Project	<b>IEEE 802.16 Broadband Wireless Access Working Group</b> < <a href="http://ieee802.org/16">http://ieee802.org/16</a> >	
Title	<b>Complementary document for draft comments</b>	
Date Submitted	<b>2003-11-11</b>	
Source(s)	Yossi Segal Itzik Kitroser Yigal Leiba Zion Hadad Runcom Technologies Ltd. 2 Hachoma St. 75655 Rishon Lezion, Israel	Voice: +972-3-9528440 Fax: +972-3-9528805 <a href="mailto:yosiss@runcom.co.il">yosiss@runcom.co.il</a> <a href="mailto:itzikk@runcom.co.il">itzikk@runcom.co.il</a> <a href="mailto:yigall@runcom.co.il">yigall@runcom.co.il</a> <a href="mailto:zionh@runcom.co.il">zionh@runcom.co.il</a>
	Avi Freedman Hexagon System Engineering 21c Yegi'a Kapa'im st. P.O. Box 10149 Petach Tikva, 49001 Israel	Voice: +972-3-9224420 Fax: +972-3-9224396 <a href="mailto:avi@hexagonltd.com">avi@hexagonltd.com</a>
Re:	Contribution elaborating on comments for letter ballot #13	
Abstract	This document includes text referenced in several comments given for ballot 13

## Complementary document for ballot 13 comments

Figure 246a— Channel Coding Process for regular and repetition coding transmission

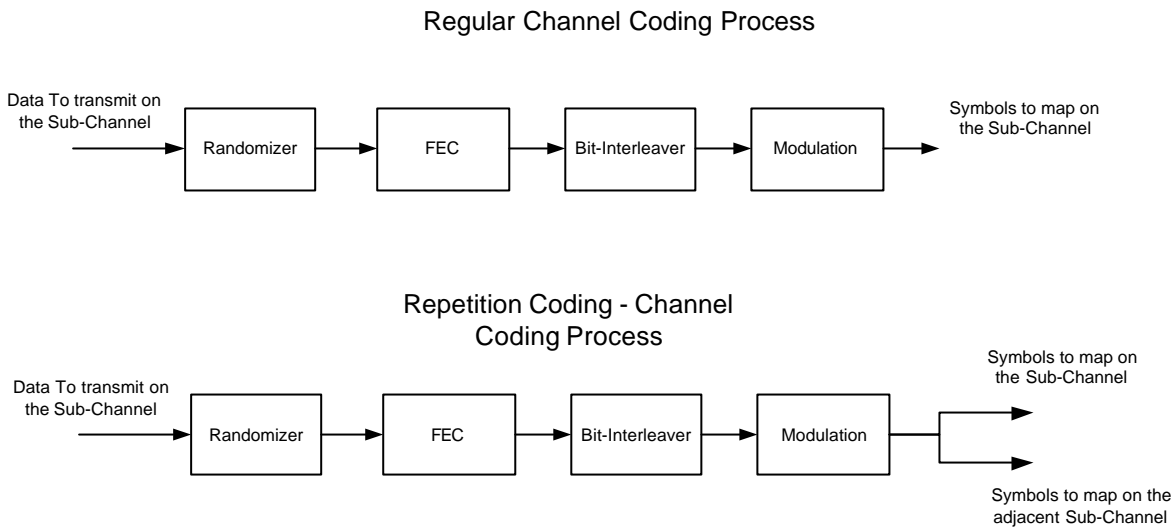
When repetition code is used, allocation for the transmission shall always include an even number of adjacent Sub-Channels. The basic block shall pass the regular coding chain where the first Sub-Channel shall set the randomization seed used in section 8.5.9.1, and the data shall follow the coding chain up to the Mapping. The data outputted from the modulation (section 8.5.9.4) shall be mapped onto the block of sub-channels allocated for the basic block and then it will be also mapped on the following consecutive allocated Sub-Channels (for repetition coding of 2 another block of sub-channels of the same size is used, while for repetition coding of 4 another 3 blocks of sub-channels of the same size are used), the process of regular encoding and repetition encoding is shown in figure 246a

**Figure 240a - Inital-ranging transmission for OFDMA, using 2 consecutive inital ranging codes**

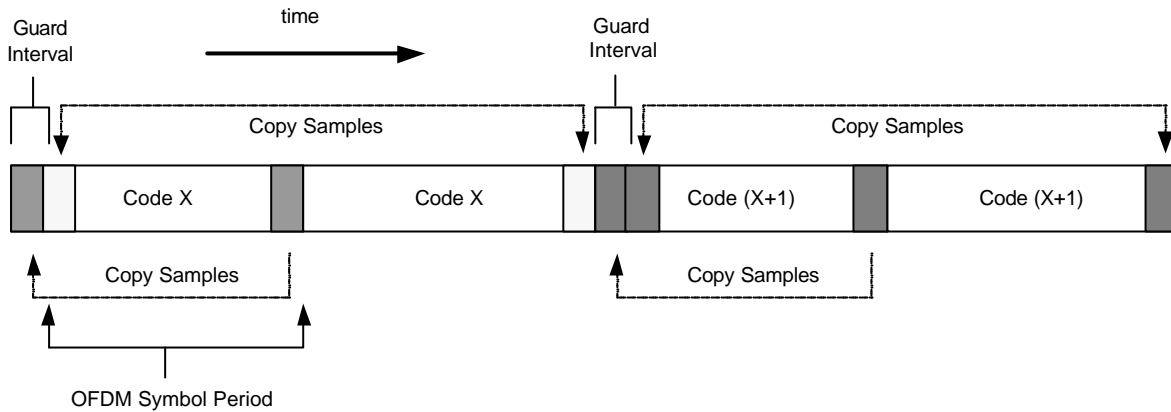
fix figure 240 to look like the first half of figure 240a and add after figure 240:

The BS can allocate two consecutive initial ranging slots and onto those the SS shall transmit the two consecutive initial ranging codes (starting code shall always be a multiple of 2), as illustrated in figure 240a;

**Figure 241—Periodic-ranging or bandwidth-request transmission for OFDMA Using one code**

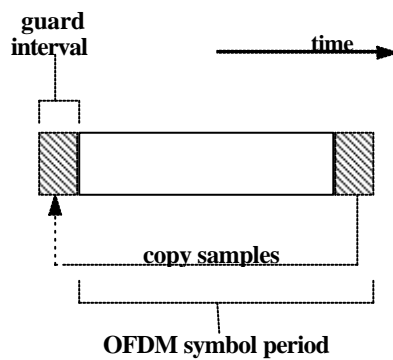
- 1) ~~shall modulate~~ Modulating one ranging code on the ranging subchannel for a period of one OFDM symbol. Ranging subchannels are dynamically allocated by the MAC and indicated in the UL-MAP. A time-domain illustration of the periodic-ranging or bandwidth-request transmission is shown in Figure 241.

**Figure 241a - Periodic-ranging or Bandwidth-request transmission for OFDMA, using 3 consecutive codes**

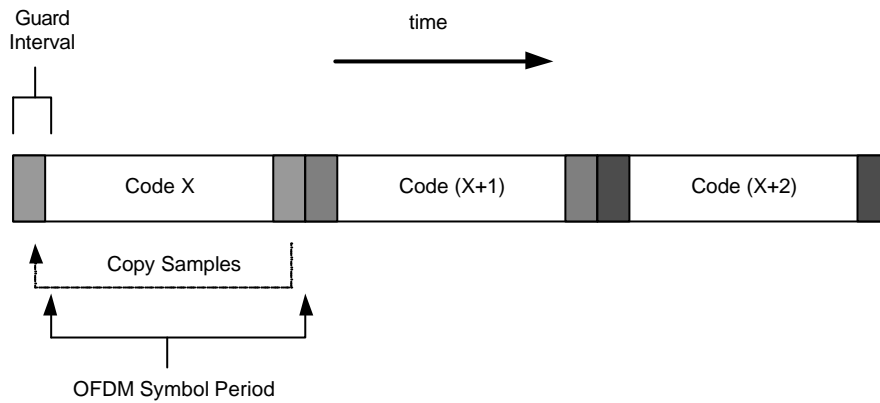
- 2) Modulating three consecutive ranging codes (starting code shall always be a multiple of 3) on the ranging subchannel for a period of three OFDM symbols (one code per symbol). Ranging subchannels are dynamically allocated by the MAC and indicated in the UL-MAP. A time-domain illustration of the periodic-ranging or bandwidth-request transmission is shown in Figure 241a.
